#### CERTIFICATE OF APPROPRIATENESS

Applicant: David M. Gorham, Owner

Property: 501 Avondale Street, Lot 8, Block 2, Montrose Subdivision. The property includes a historic 3,068

Proposal: Alteration - Addition

**EXISTING WEST ELEVATION**

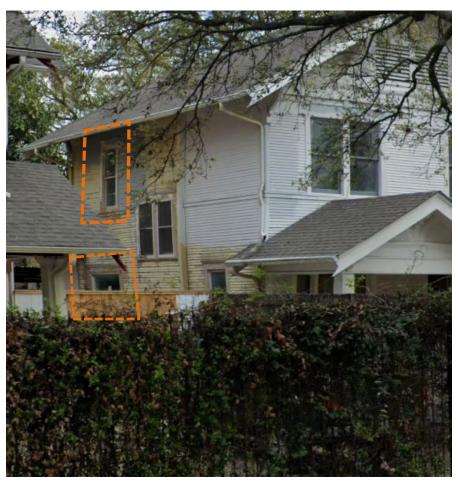
Non- original plate glass window B

2<sup>nd</sup> floor window A or W33 proposed to be removed

proposed drawing set for addition, except for the following conditions on the west elevation. Retain and repair historic second floor window (A or w33). Non-original first floor plate glass window (B or w36) should be altered to match historic photo (similar in dimension to window

D or w16). Window D to be repaired and remain in place.

#### **CURRENT PHOTOS - EAST ELEVATION OPENINGS**

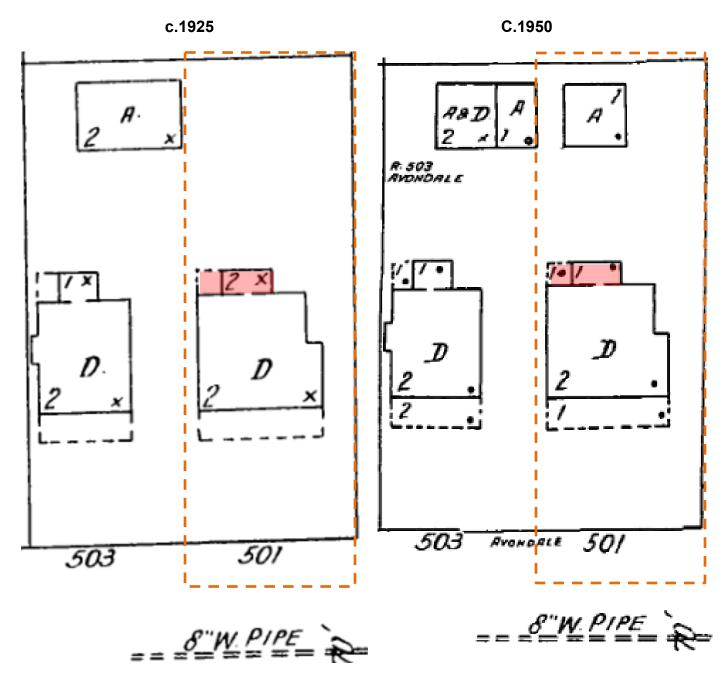
WINDOW W8 – PLATE GLASS WINDOW TO BE REMOVED PROPOSED REPLACEMENT TO MATCH 10 PANE WINDOWS TO RIGHT.

EXISTING - JULY 2020

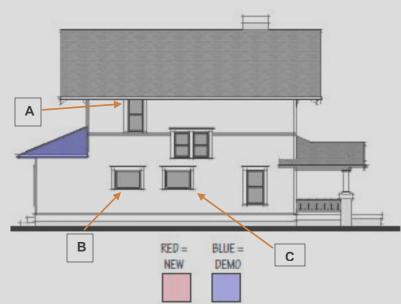
Existing drawing incorrect, see end of report for details on actual window openings

#### **EXISTING - CURRENT \*REAR ADDITION ALREADY DEMOLISHED**

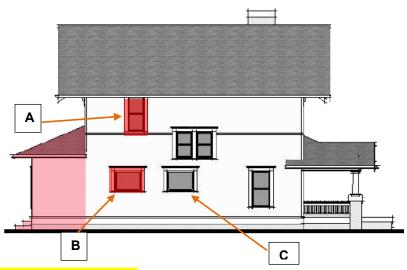
Existing drawing incorrect, see end of report for details on actual window openings

#### WEST ELEVATION WINDOWS -EXISTING \*DRAWING INCORRECT

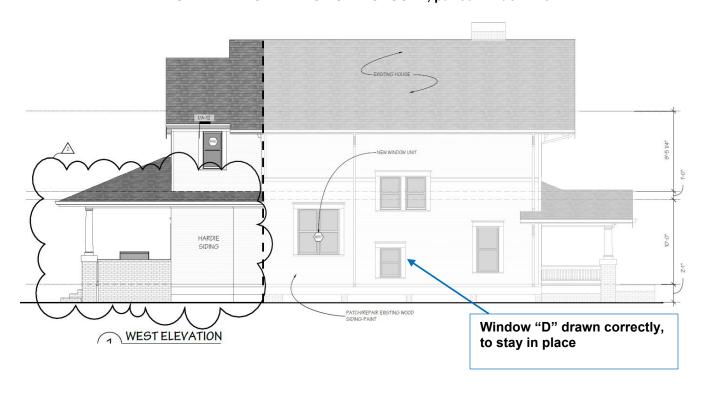
- Alteration of window openings on the west elevation: remove window A (W33) on second floor and B (W36) on the first floor. Patch and repair siding to match and install new paired wood window (W37).

#### **EAST ELEVATION WINDOWS - PROPOSED**

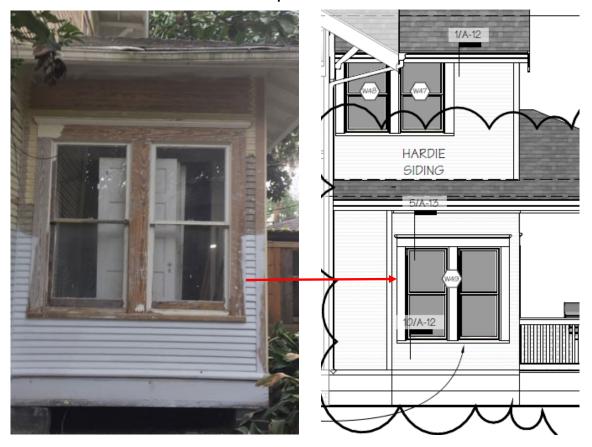
W49 - re-install historic paired windows in new addition
